S303-S159

**SERVICE****TECHNICAL BULLETIN**

Engine In Limp Home/Check Engine MIL –  
Water Ingress into Throttle Position Sensor –  
Service Action S159

MODEL 2003-04 MY  
S-TYPE R

ILLUSTRATION 1

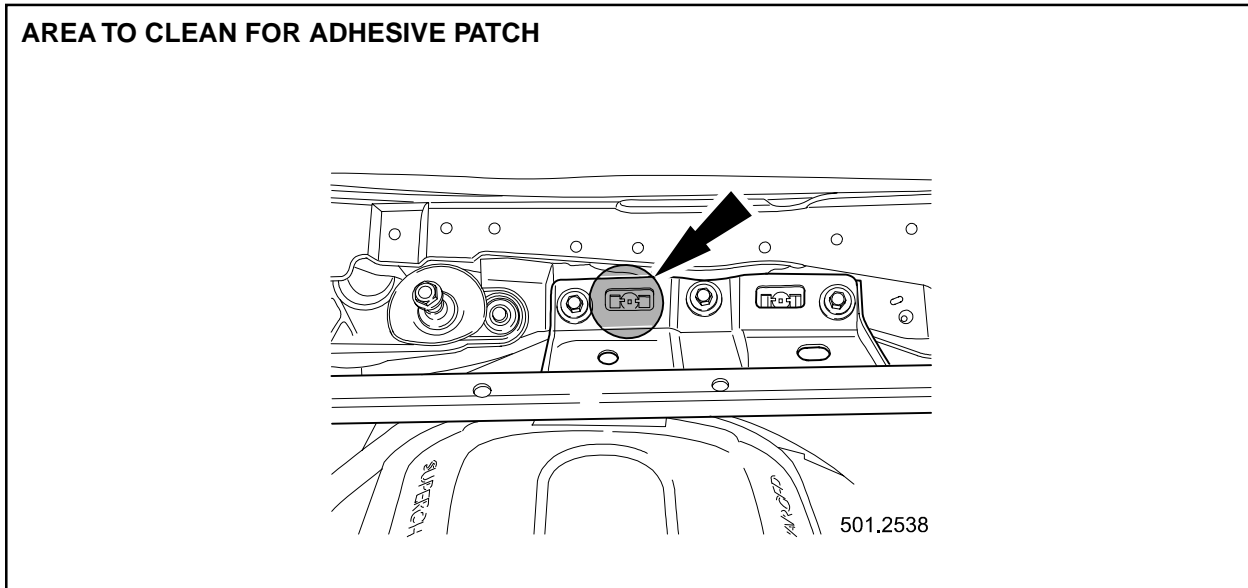
A concern has been identified on 2003-04 MY S-TYPE R vehicles within the above VIN range. It is possible that during washing of the vehicle, by car wash or jet wash, the water can run through the cowl panel grille-fixing hole into the throttle position sensor housing. This can result in the throttle position sensor failing to function, the engine management system defaults to 'limp home' mode, and a warning MIL is displayed.

A sealing patch is available to prevent water flowing directly from the cowl panel grille onto the throttle position sensor.

On 2003-04 MY S-TYPE R vehicles within the above VIN range, install a sealing patch on the mounting hole located on the suspension turret cross brace at the bracket securing it to the bulkhead.

- Clean the area indicated on the bracket of the suspension turret cross brace where it secures to the bulkhead (Illustration 1).

- Ensure the plastic insert is central in the rectangular hole of the brace.
- Remove and discard the backing from the adhesive patch and install the patch centrally over the right hand rearmost rectangular hole (Illustration 1) of the suspension turret cross brace.
- Reinstall the cowl panel grille, see Workshop Manual, JTIS CD ROM, section: 501-02, SRO 76.10.01.
- Remove fender protection kit and close hood and door.
